Metropolitan Historic Zoning Commission
Sunnyside in Sevier Park
3000 Granny White Pike
Nashville, Tennessee 37204
Telephone: (615) 862-7970
Fax: (615) 862-7974

STAFF RECOMMENDATION
1510 Paris Avenue
October 16, 2019

Application: New construction- Addition and Outbuilding
District: Belmont-Hillsboro Neighborhood Conservation Zoning Overlay
Council District: 18
Base Zoning: R8
Map and Parcel Number: 117040195.00
Applicant: Betsy Bergin
Project Lead: Jenny Warren, jenny.warren@nashville.gov

Figure 4: Rear elevation, proposed addition in red

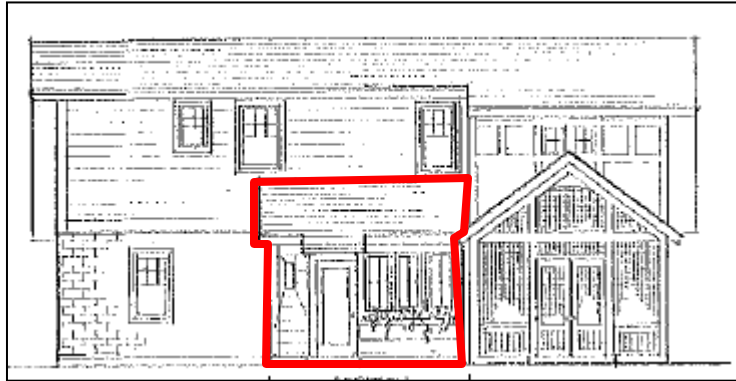
Height & Scale: The proposed addition is both shorter and narrower than the historic house. It is very modest in size, measuring approximately fourteen feet (14') by thirteen feet (13').

The addition is one story tall with a height of about thirteen feet (13'), while the back of the house is two stories tall with a height of about twenty-three feet (23').

Design: The existing house is painted brick and the addition will be lap siding. The addition's change in materials, inset, separate roof form, and lower height help to distinguish it from the historic house and read as an addition to the house. At the same time, its scale, materials, roof form, and fenestration pattern are all compatible with the historic character of the existing house. The project meets section II.B.2.a and f.

Proportion and Rhythm of Openings: No changes to the window and door openings on the existing house were indicated on the plans, beyond the removal of the rear windows to allow for the addition. The windows on the proposed addition are all generally twice as tall as they are wide, thereby meeting the historic proportions of openings. There are no large expanses of wall space without a window or door opening. Staff finds the project's proportion and rhythm of openings to meet Section II.B.1.g.

With staff review and approval of the foundation material, the siding exposure, the roof color and the final doors and windows, the project meets section II.B.1.d

Figure 5: Proposed location of addition

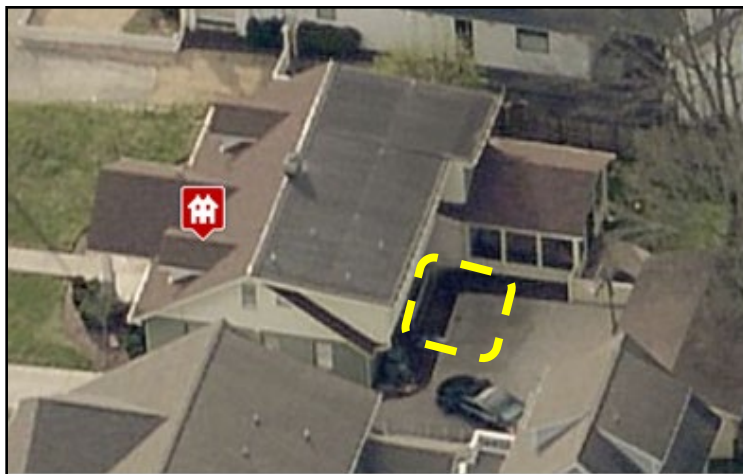
The location of the addition will be on the rear of the house, within an existing L-shape of the footprint. Thus the new construction will add neither depth nor width to the existing footprint. This location is in accordance with the design guidelines. The addition is designed so that if the addition were to be removed in the future, the historic character of the house would still be intact. The project meets section II.B.2.a and e.

Appurtenances & Utilities: No changes to the site's appurtenances were indicated on the drawings. The location of the HVAC and other utilities was also not noted. Staff asks that the HVAC be located on the rear façade, or on a side façade beyond the midpoint of the house. The project meets section II.B.1.h.

Figure 6: Proposed outbuilding – side

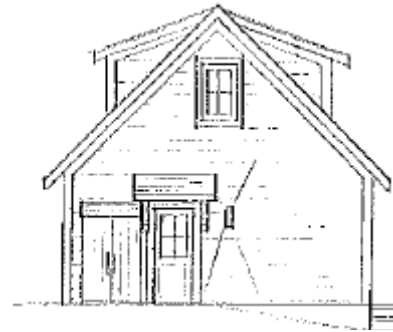
The proposed ridge height will be approximately twenty feet (20') tall, which is less than the twenty-three foot (23') tall house and less than the twenty-five foot (25') maximum. The eave heights will vary a bit, due to grade, but will be an average of about nine feet (9') tall which meets the guidelines.

The primary roof form is gabled, which is appropriate. There are dormers on both roof slopes. The dormers are set in the required two feet (2') from the wall below and do not occupy more than fifty percent (50%) of the roof plane, as per the guidelines. Staff finds that the proposal meets Section II.B.1.i of the design guidelines for roof shape.

With staff's final approval of the foundation material, siding exposure, roofing color, windows, doors and garage doors, staff finds that the materials meet the design guidelines.

Figure 7: Proposed site plan – arrow indicates 16’ (sixteen feet) of separation from the rear wall of the house to outbuilding

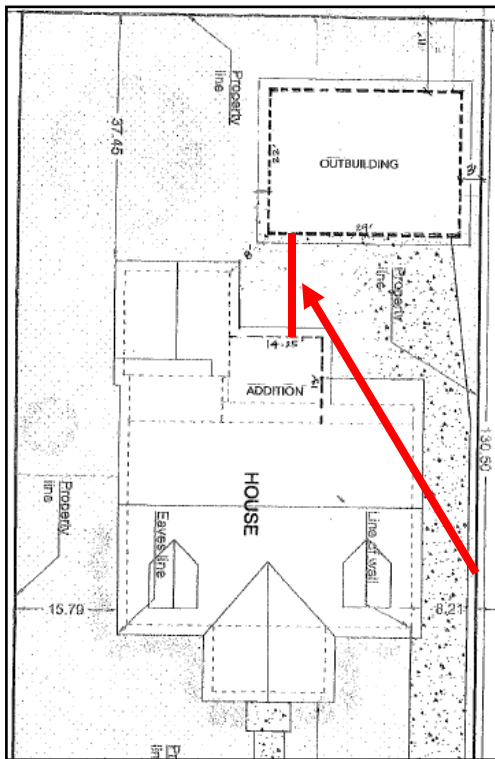
The guidelines state that ‘*there should be a minimum separation of 20’ between the principal structure and the DADU or outbuilding*’. The applicant is proposing sixteen feet (16’) of separation between the back of the new addition and the outbuilding. Staff finds that this could be appropriate, because the lot is shallow, at one-hundred-thirty feet (130’) deep. In the past, the Commission has allowed applicants to reduce the distance between the house and outbuilding if the lot is less than one-hundred-fifty feet (150’) deep.

Staff finds that the project meets section II.B.1.i of the design guidelines.
